BAROSSA ASSESSMENT PANEL

6.1 26014901 - 10 Duck Ponds Road Stockwell

PROPOSAL	Construction of a store building to the rear of an existing dwelling
APPLICANT	Adam Mrotek, Mrotek Town Planning
OWNER	Brenton Reimann
APPLICATION NO	26014901
CERTIFICATE(S) OF TITLE	CT 5306/536
AREA	1,518 square metres
CURRENT USE	Residential
PLANNING AND DEVELOPMENT CODE VERSION	Version 2026.10 – 28 May 2026
PLANNING AND DESIGN CODE EXTRACT LINK	Relevant Code Extract
ZONE	Township Zone
OVERLAYS	Character Preservation District (Township) Historic Area (Baro7) Hazards (Bushfire - Urban Interface) (Urban Interface) Hazards (Flooding - Evidence Required) Native Vegetation Prescribed Water Resources Area
RELEVANT AUTHORITY	Assessment Manager (Delegated to Assessment Panel)
APPLICATION TYPE	Code Assessed – Performance Assessed
PUBLIC NOTIFICATION	Not Notified
REFERRALS	Nil
PREVIOUS APPLICATIONS	Nil
ASSESSING OFFICER	Alex Phillis – Assessment Officer Planning
RECOMMENDATION	That Planning Consent be GRANTED subject to Conditions

Re: Applicant Response to Council Request for Documentation – DA:26014901 – Domestic outbuilding in association with existing building

JOB: ECO-WASTE-COMPOST-SOLUTIONS-AJ1034C-1034C-2026
CLIENT: Mr & Mrs Reimann
SHEET: Rear Elevation
DRAWN BY: Loren Miller
REV DATE: 28/7/2026

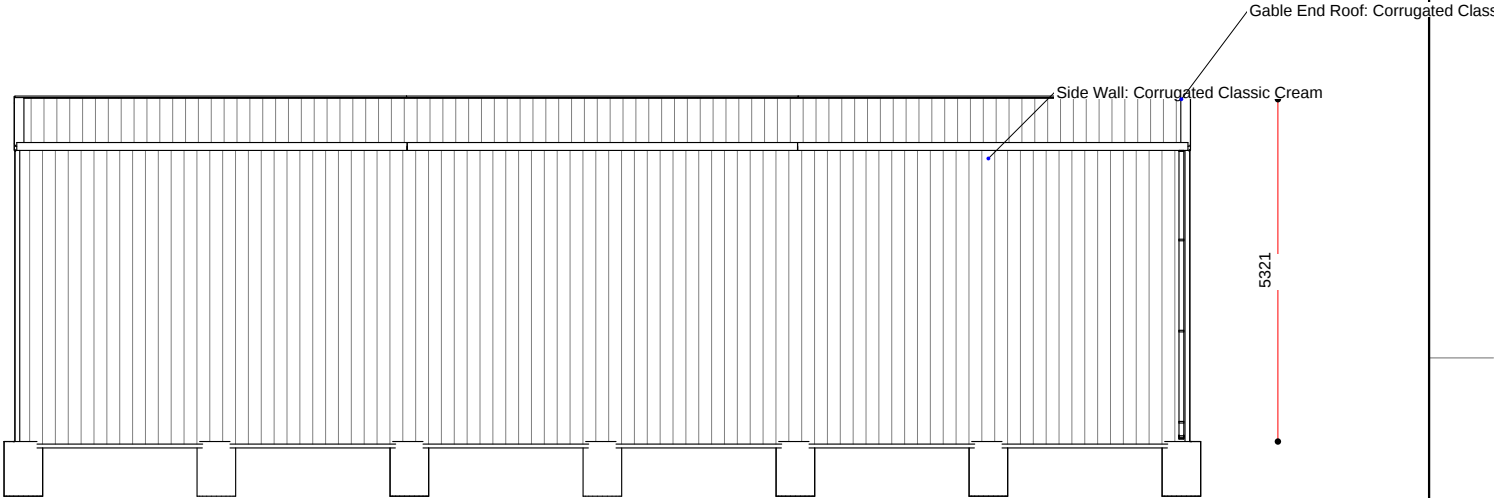
- **Attachment A** and amended plans changing the land use from outbuilding (shed) to a store, increase to the rear boundary setback from 1.4m to 2.4m, change to external cladding from Alpha Clad to Corrugated profile wall and roof metal sheeting and landscaping plan,
- **Attachment B** and photos of collector vehicles (trucks) and caravan to be stored,
- **Attachment C** landscaping plan; and
- **Attachment D** and cross section showing opening or day light door, including carry beam and roller barrel.

JOB: ECO-WASTE-COMPOST-SOLUTIONS-AJ1034C-1034-2026
CLIENT: Mr & Mrs Reimann
SHEET: Right Elevation (3)

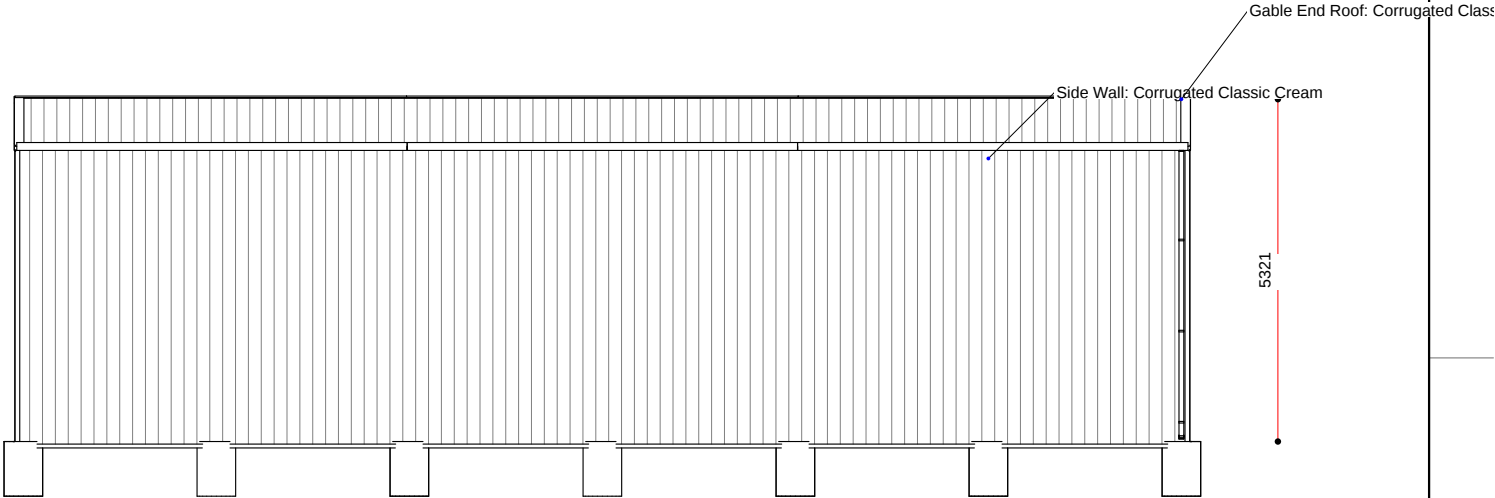
3. Stormwater management It is noted there are water tanks nominated on the site plan. Please provide confirmation of the capacity of the water tanks. I would also ask for some demonstration of how stormwater from the proposed building will be managed in the event that the tanks reach capacity during a rain event.

Overflow stormwater from rainwater tanks will be directed to the street water table via a pressurised pipe system. Refer amended plan for details.
